TAV.106 MOD. LN43

TAV. 107 MOD. L N 43

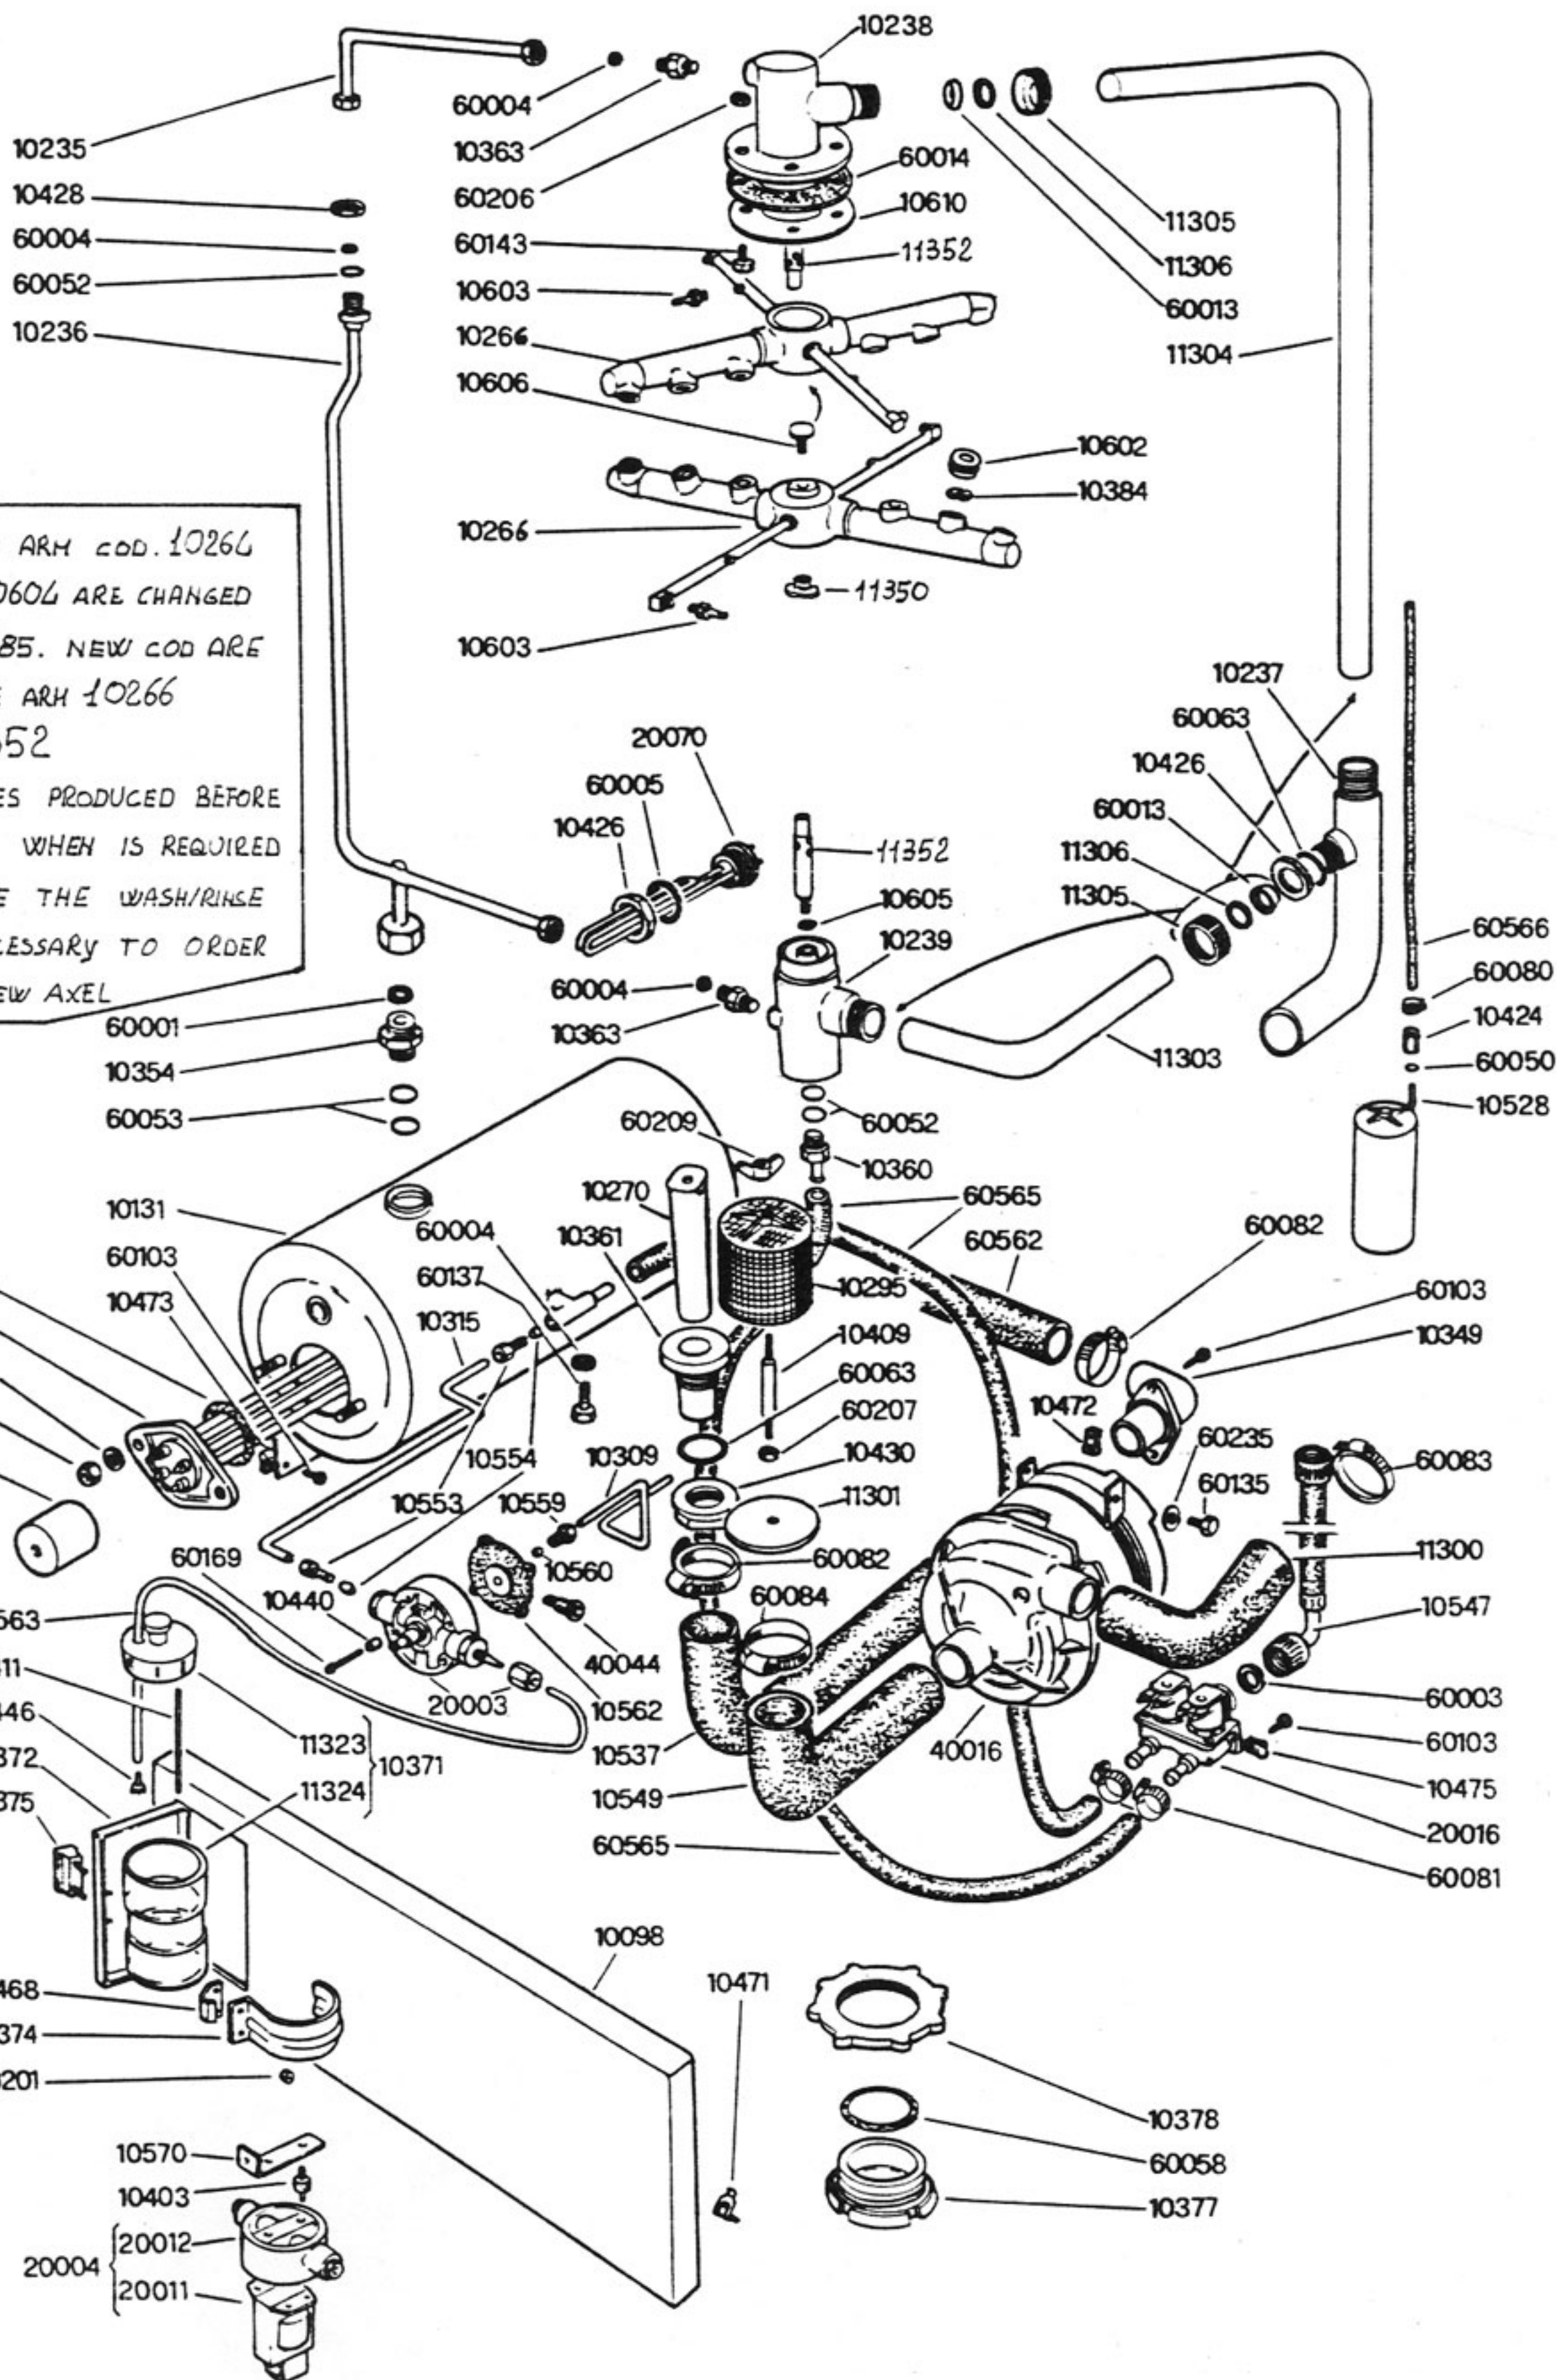
WASH/RINSE ARM COD. 10266
 AXEL COD. 10606 ARE CHANGED
 FROM 1/1/85. NEW COD ARE
 WASH/RINSE ARM 10266
 AXEL 11352
 ON MACHINES PRODUCED BEFORE
 THIS DATE WHEN IS REQUIRED
 TO CHANGE THE WASH/RINSE
 ARM IS NECESSARY TO ORDER
 ALSO THE NEW AXEL
